Project	IEEE 802.16 Broadband Wireless Access Working Group < http://ieee802.org/16 >	
Title	Modification of Open loop STC	
Date Submitted	2004-04-28	
Source(s)	Chan-Byoung Chae, Wonil Roh, Sung-Ryul Yun, Kyunbyoung Ko, Hongsil Jeong, JeongTae Oh, Seungjoo Maeng, Panyuh Joo, Jaeho Jeon, Jerry Kim, Soonyoung Yoon, K. Sivanesan, Marcos Katz, DS Park	cb.chae@samsung.com
	Samsung Electronics Co., Ltd.	
	Jianzhong (Charlie) Zhang, Anthony Reid, Kiran Kuchi, Heikki Berg, Nico Van Waes	Charlie.Zhang@nokia.com
	Nokia Research Center	
Re:		
Abstract	Modification of the open loop STC for 3, 4 Tx	
Purpose	Adoption of proposed changes into P802.16e	
	Crossed-out indicates deleted text , <u>underlined blue indicates new text change to the Standard</u>	
Notice	This document has been prepared to assist IEEE 802.16. It is offered as a basis for discussion and is not binding on the contributing individual(s) or organization(s). The material in this document is subject to change in form and content after further study. The contributor(s) reserve(s) the right to add, amend or withdraw material contained herein.

Modification of Open loop STC

Fig 1. An example of the choice of subscript k to determine the Matrix A.

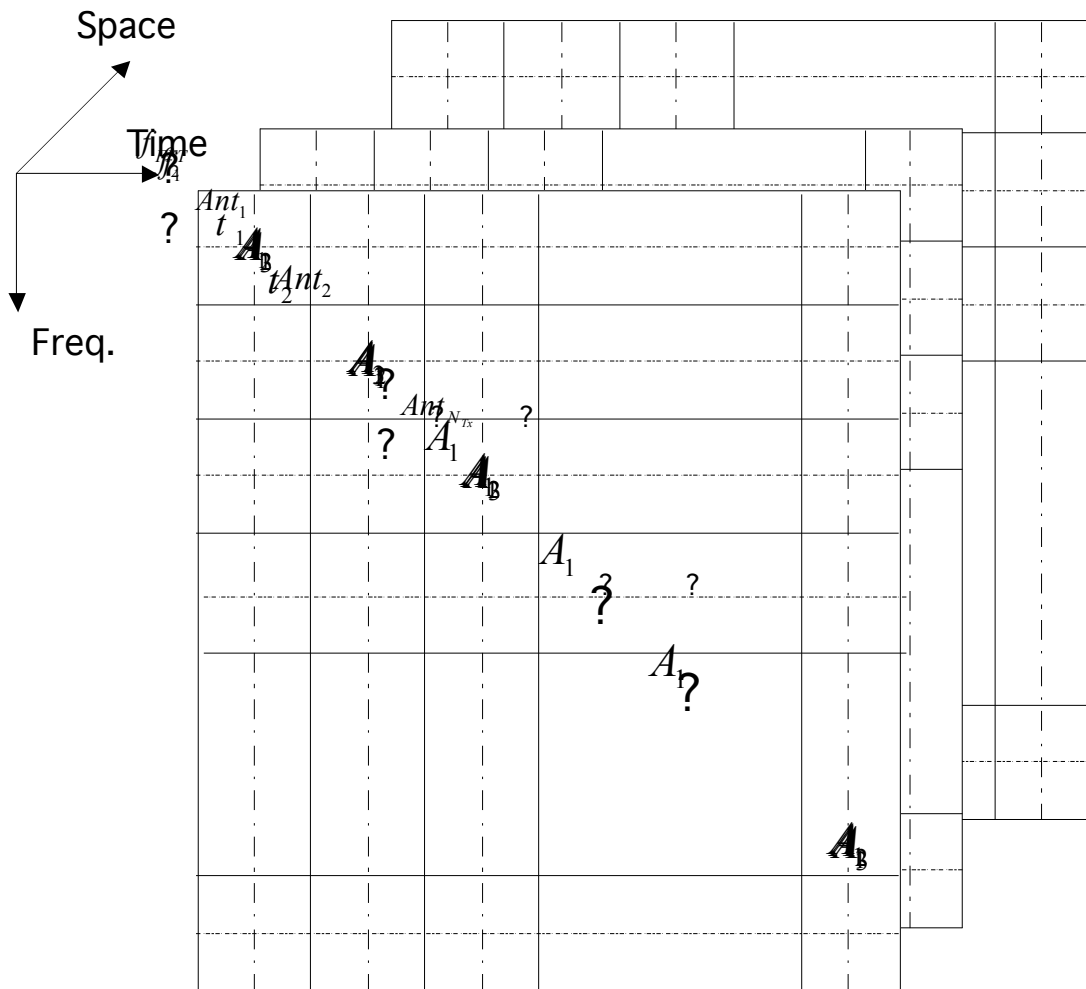
Since, there are space-time-frequency codes (over two OFDMA symbols and two sub-carriers) in [1], we propose a modification of the 3 Tx antenna STC for rate 1 and 2, i.e., Matrix A, Matrix B, should be changed to:

$$k = \text{mod}(\text{floor}(\frac{\text{logical_data_sub-carrier_number_for_first_tone_of_code} - 1}{2}), 3) + 1$$

In addition, the above equation can be applied to the 4Tx antenna rate 1 (Matrix A).

where, $\text{logical_data_sub-carrier_number_for_first_tone_of_code} = 1, 2, 3, \dots$, total number of data subcarriers.

~~In optional FUSC zones, t~~The index k , of permuted version of Matrix A and B to use for a particular deployment is given by : ~~$k = \text{mod}(\text{logical_data_sub_carrier_number_for_first_tone_of_code}, 3) + 1$~~ $k = \text{mod}(\text{floor}(\frac{\text{logical_data_sub_carrier_number_for_first_tone_of_code} - 1}{2}), 3) + 1$, where ~~logical_data_sub_carrier_number_for_first_tone_of_code=1,2,3,...~~ Total # of data sub-carriers.
